November 6, 1989
Fort St. Vrain
Unit No. 1
P-89427

**Public Service
Company of Colorado**
P.O. Box 840
Denver CO 80201-0840

SUBJECT: Defueling SAR Request for
Additional Information

Figure 1

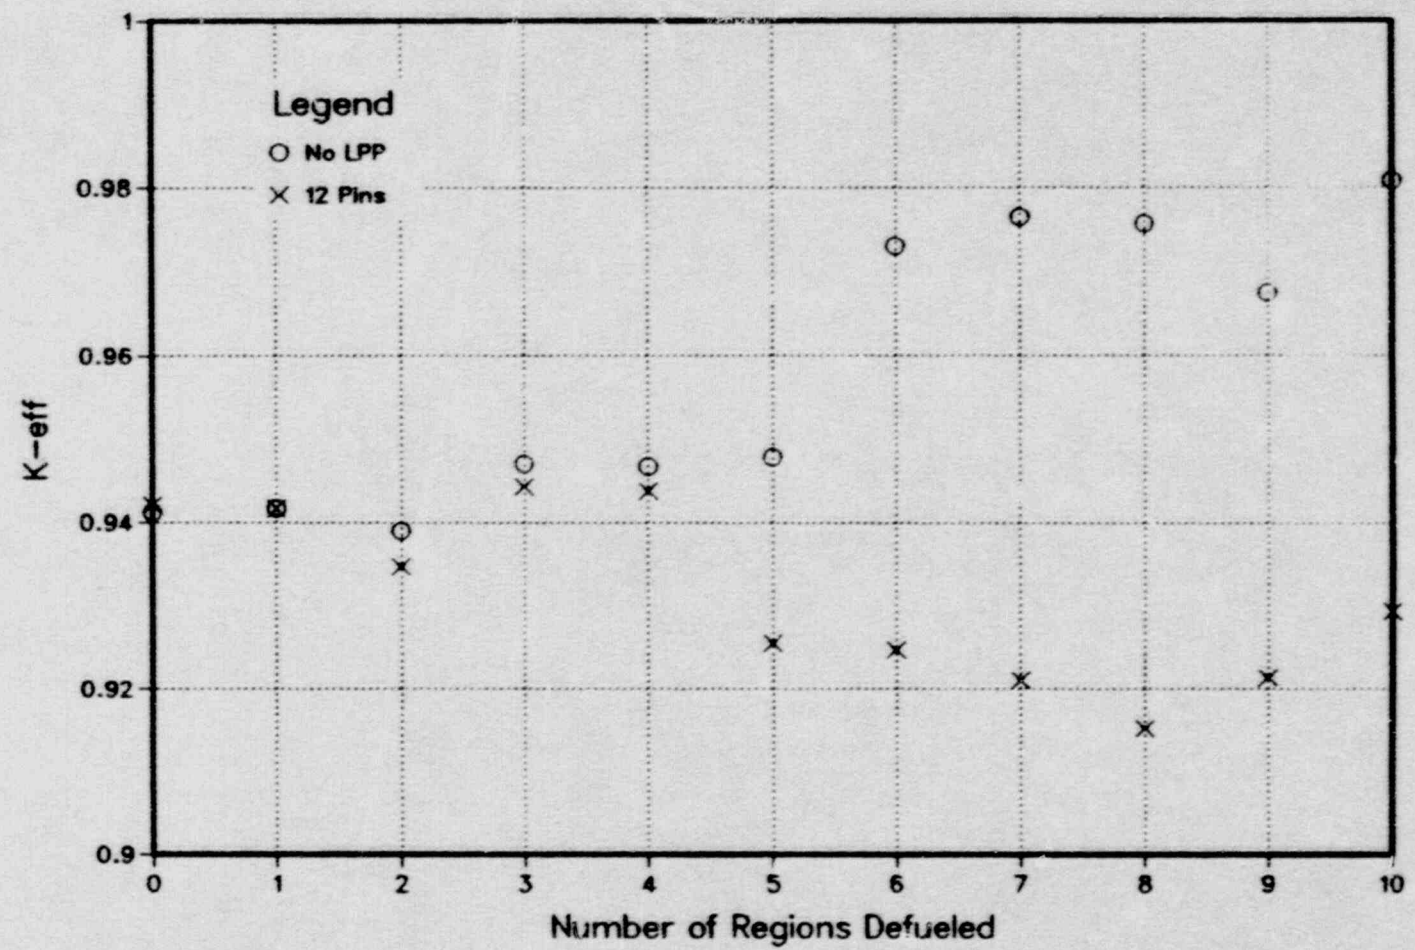
NRC Requests: The licensee should provide actual calculated results with the boron model for 0 ppm boron for defueling the first 10 regions. These calculations should demonstrate consistency with the 12 pin boron results presented in the Defueling SAR.

PSC Responses: Two reactivity cases were calculated using the boronation model for 0 ppm boron and 12 pin boron (12 lumped poison pins in each defueling element). Figure 1 shows the calculated data points for reactivity as a function of the number of regions defueled with the shutdown margin verification rods withdrawn consistent with Table 3-2 of the Defueling SAR. Figure 2 shows a similar calculation except that all the rods are all inserted in the active core. Because the effects of control rod withdrawal from regions of varying reactivity worth are not superimposed, Figure 2 provides a better representation of the decrease in reactivity that occurs, with the use of boronated defueling elements, as fuel is removed and the active core shrinks in size. The models show a consistent reactivity value for zero regions defueled.
